UNITED STATES
NUCLEAR REGULATORY COMMISSION
WASHINGTON, D.C. 20555-0001

November 10, 1993

SUBJECT: WATTS BAR NUCLEAR PLANT - PROVIDING TVA'S WRITTEN RESPONSE TO
VERBAL QUESTIONS ON THE CIVIL CALCULATION PROGRAM AUDIT
(TAC R00514)

Figure 1. General Layout

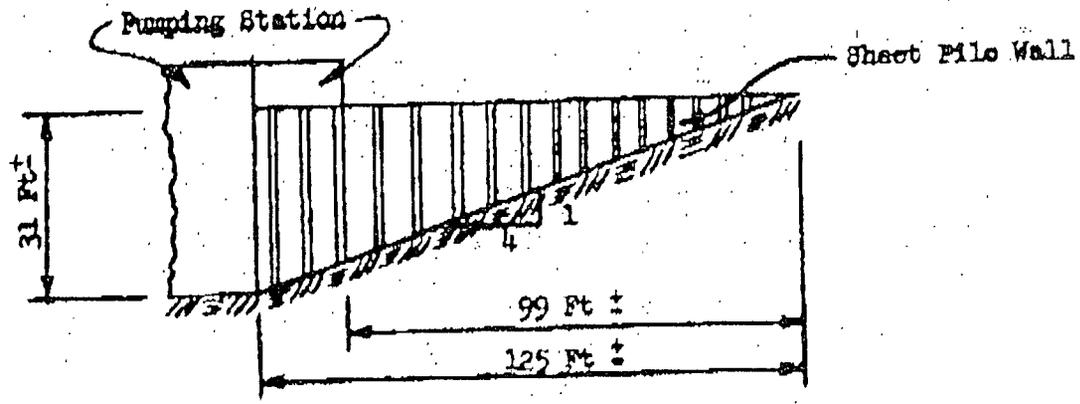
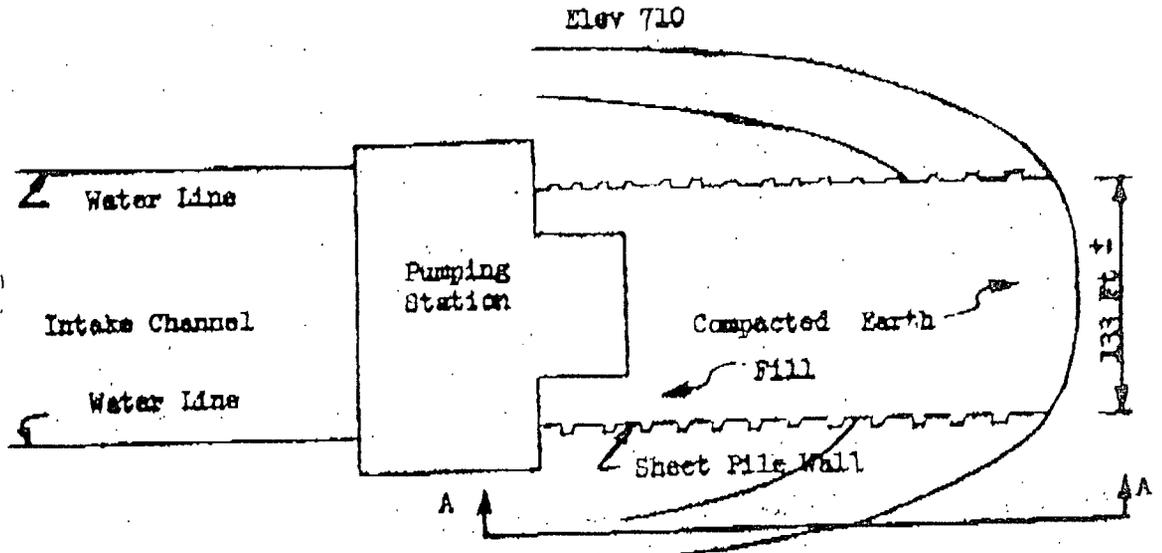
Discuss the applicability of "SHAKE" program for determination of frequency dependent shear stresses in the backfill contained within the sheet pile walls at the intake pumping station.

The plan and section of the intake pumping station and sheet pile walls are attached. The distance between the sheet pile walls is 133 feet. The length of the sheet piles wall is 125 feet. The maximum backfill depth is 31 feet and reduces to zero along the sheet pile wall length. Natural earth surrounds the sheet piles over much of the area, thus providing confining pressure. The sheet piles themselves are tied to each other by tie rods and deadmen. This information is available in WCG-1-1369 Revision 2.

Since natural earth surrounds the sheet piles over most of the area and the sheet piles are tied to each other with tie rods and deadmen and contain compacted backfill, the complete system adequately models a soil system that extends indefinitely in the horizontal direction which is implied in the "SHAKE" program. As such, the "SHAKE" program is appropriate for the analysis.
